Series 90

42cc Axial Piston Pump

Service bulletin

Side cover washer elimination

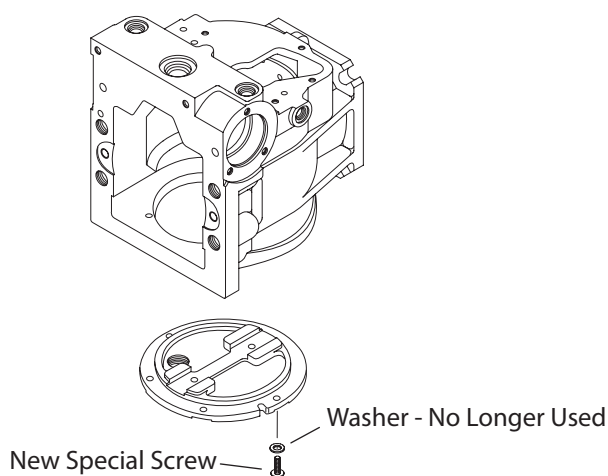
Change took place during the 2nd and 3rd quarter of 1994

Charge pump shaft key change

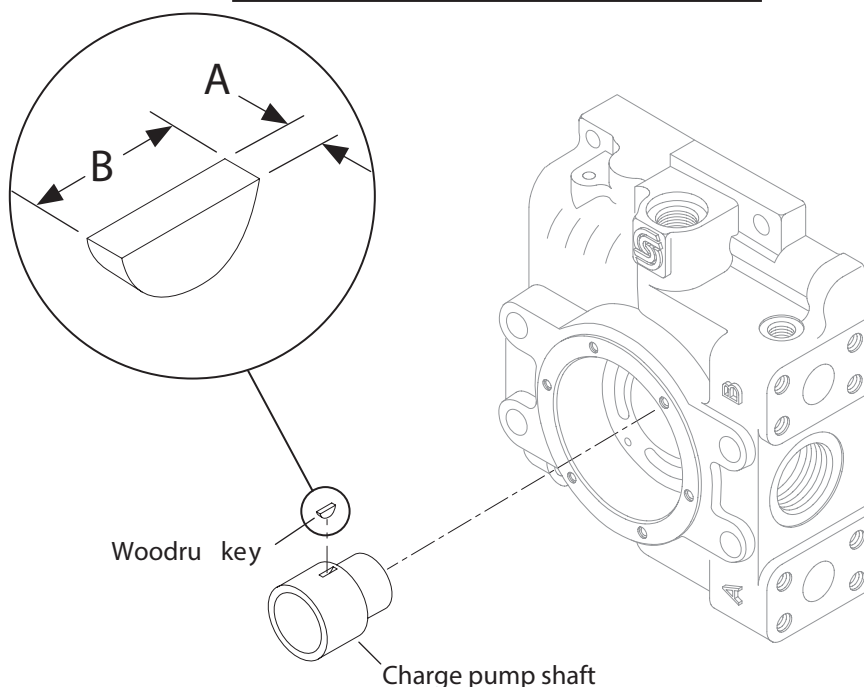
As a product improvement, Sauer-Danfoss has made a design change to the charge pump shaft and woodruff key used on 42 cc variable pumps

This is an interchangeable change within the affected serial number range, if the charge pump shaft and key are replaced together.

Width "A" mm (in)	Length "B" mm (in)
Old key	3.14 (0.1235)	12.70 (0.500)
New key	3.09 (0.1215)	9.53 (0.375)

Manual displacement control (MDC) with DC electric solenoid override

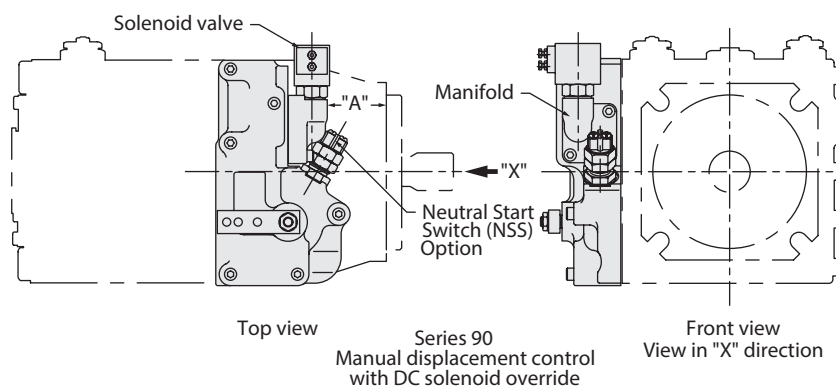
In order to accommodate our European customers, the manifold which attaches to the front of the manual displacement control (MDC) housing is being changed.

The European solenoid valve requires a thicker manifold to provide clearance between the solenoid and the front of the MDC housing. The revised manifold will protrude closer to the mounting flange of the pump, reducing dimension "A" shown in the accompanying drawing by approximately 5 mm [0.2 in]. Please see chart below for specific clearances.

This change will become effective during March of 1995. The old manifold will be obsoleted and no longer available as a service part.

Charge pump design change

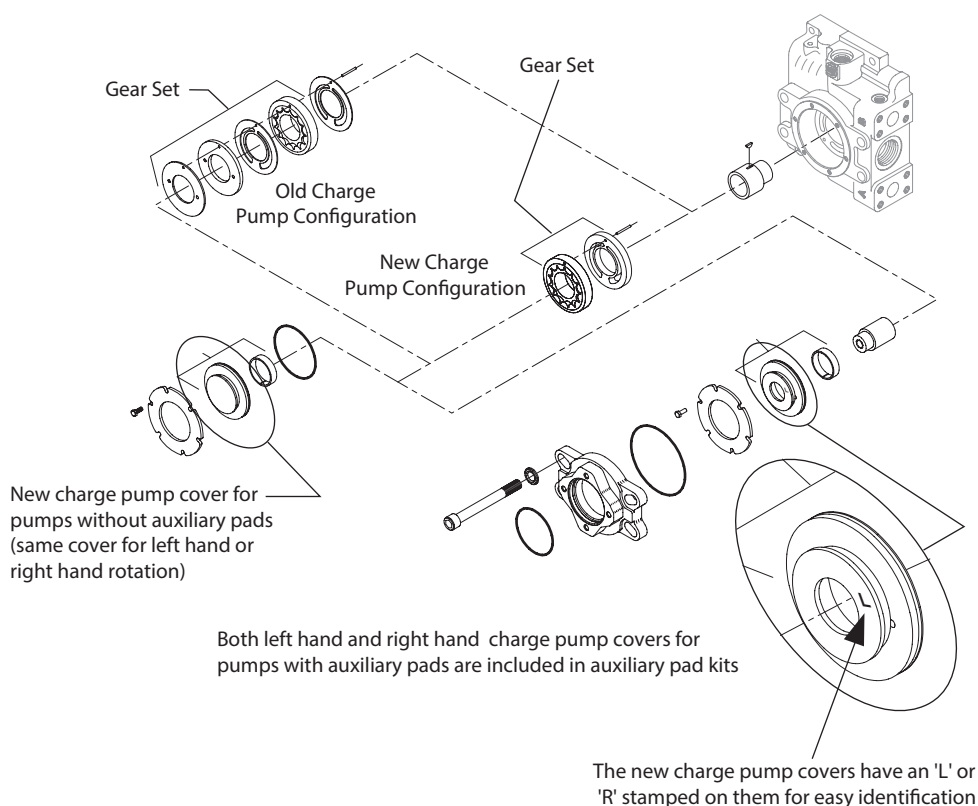
Part numbers affected The following information must be known to determine the correct charge pump replacement kit:

End cap bolt size change

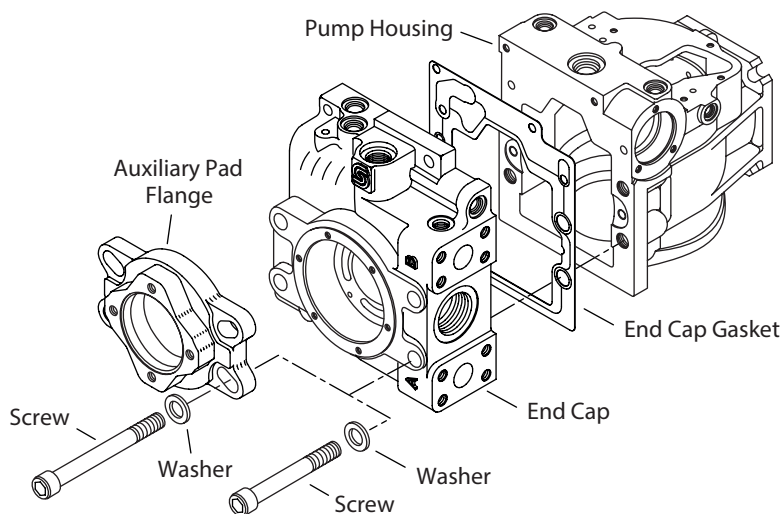
As a product improvement, Sauer-Danfoss is changing the screws that fasten the end cap to the pump housing from M10 to M12.

This change will require a new housing, end cap gasket, end cap, auxiliary mounting pad flange, and screws.

The new end cap and gasket can be used the old housing if hardened washers are used with the M10 end cap screws.

Subject Side cover design change

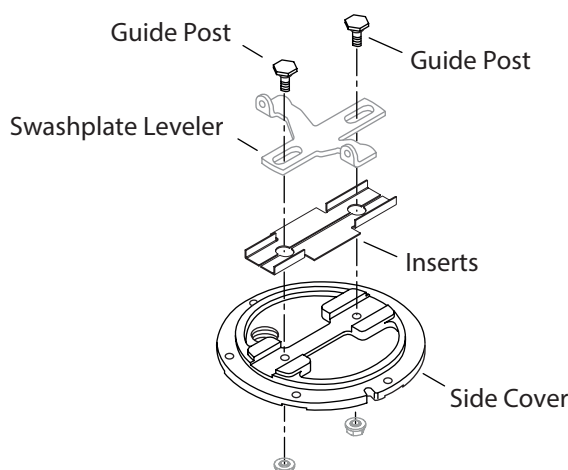
Description As a product improvement, Sauer-Sundstrand is changing the side cover and swashplate leveler (T-Bar) guide post design.

The new design side cover will have two hardened inserts in the machined slot which serves as a guide for the swashplate leveler, and modified guide posts. The swashplate leveler does not change.

Serial numbers Change occurred at serial number N-96-08-xxxxx.

Auxiliary flange charge pump cover

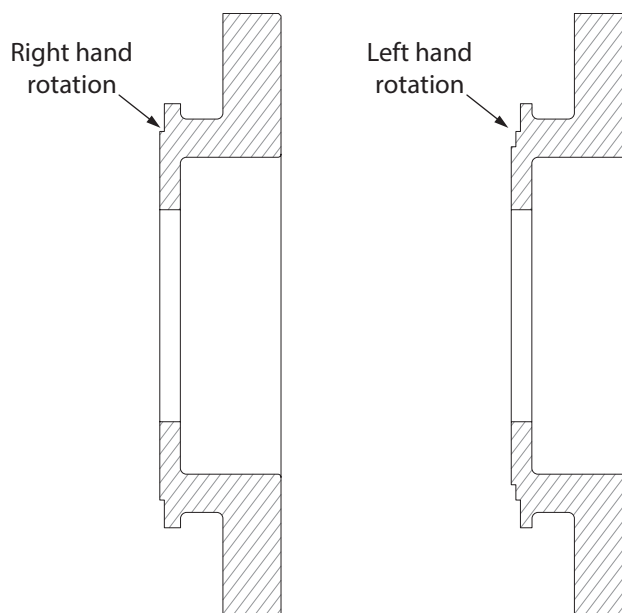
The part numbers of the charge pump covers will not change.

This change became effective at serial number A-05-17-xxxxx

SAE A auxiliary mounting flange, O-ring seal

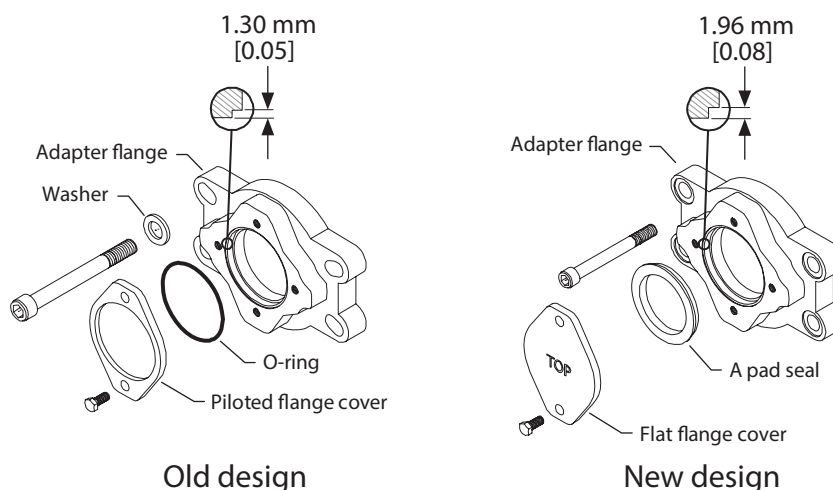
Sauer-Danfoss is pleased to announce a design improvement on the SAE A auxiliary mounting flange adapter on its series 90 pumps. The frame sizes affected by this change are 42, 130, 180 and 250cc. All manufacturing locations producing these pumps will be changed to this configuration.

The pumps will now be supplied with the donut style seal and new flat cover, instead of the small O-ring and stepped cover plate (shown in the drawing below).

Change became effective at serial number N-09-30-xxxxx. (20 July 2009)

SAE B auxiliary mounting flange, O-ring seal

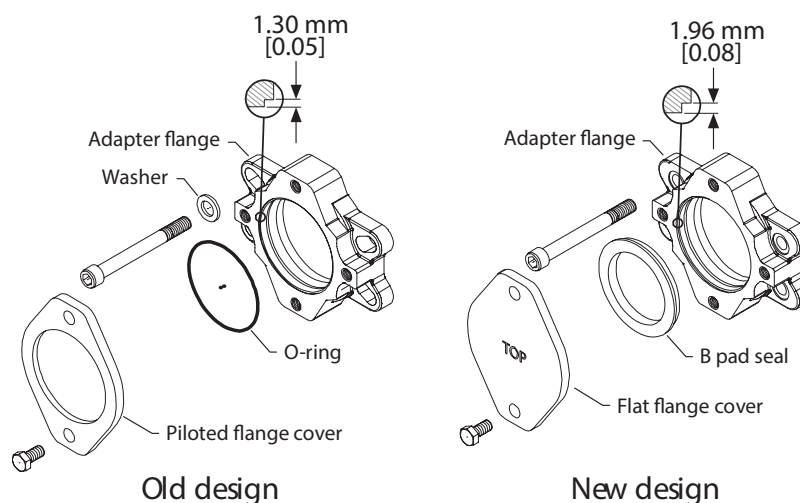
Sauer-Danfoss is pleased to announce a design improvement on the SAE B auxiliary mounting flange adapter on its series 90 pumps. The frame sizes affected by this change are 42, 130, 180 and 250cc. All manufacturing locations producing these pumps will be changed to this configuration.

The pumps will now be supplied with the donut style seal and new flat cover, instead of the small O-ring and stepped cover plate (shown in the drawing below).

Change became effective at serial number N-09-30-xxxxx. (20 July 2009)

SAE C auxiliary mounting flange, O-ring seal

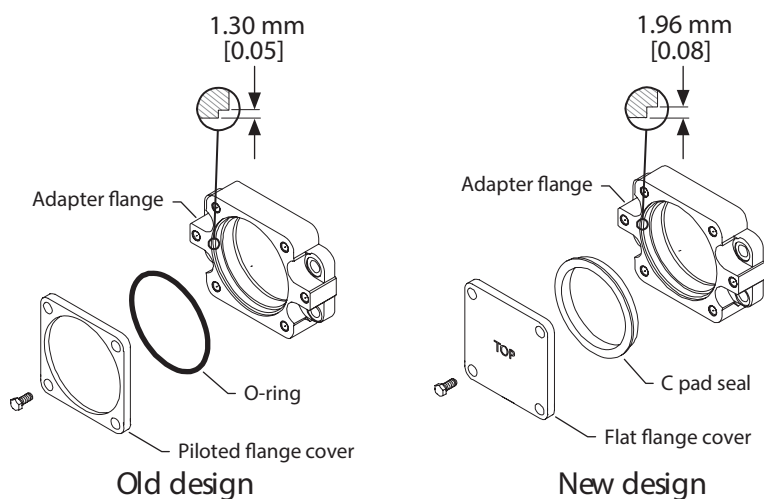
Sauer-Danfoss is pleased to announce a design improvement on the SAE C auxiliary mounting flange adapter on its series 90 pumps. The frame sizes affected by this change are 130, 180 and 250cc. All manufacturing locations producing these pumps will be changed to this configuration.

The pumps will now be supplied with the donut style seal and new flat cover, instead of the small O-ring and stepped cover plate (shown in the drawing below).

Change became effective at serial number N-09-30-xxxxx. (20 July 2009)
